**Bid No: ITB 2017718**  
**Name of Bid: Horace O'Bryant Bus Loop**  
**Post Date: 4/12/17**  
**Notice Post Time: 3:00 PM**

**Addendum No.1**

NEW BUS DROPOFF/PICKUP

STRUCTURAL PLAN AND DETAILS

WALKWAY SECTION - WITH EDGE PROTECTION  
SCALE: 1" = 1'-0"

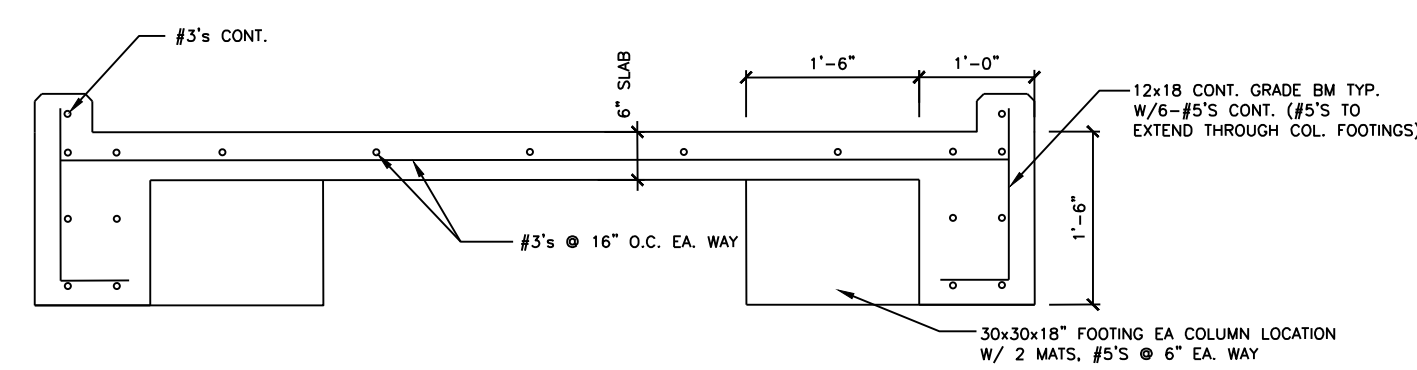
2. "Walkway Section - With Edge Protection" on sheet S-1 does NOT specify the width or height of the Concrete Curb. Please specify these dimensions as well as any rebar requirements.  
*Response: The curb is 6" wide and 6" in height. Rebar requirements are (1)#3 longitudinal, see walkway section on S-1.*

3. "Walkway Section - With Edge Protection" on sheet S-1 reads "12x12 Cont. Grade Bm Typ.", however, the dimensions show 1'-0" wide x 1'-6" deep. Please confirm which is correct.  
*Response: Concrete grade beam 12"x18" typical, updated on sheet S-1.*
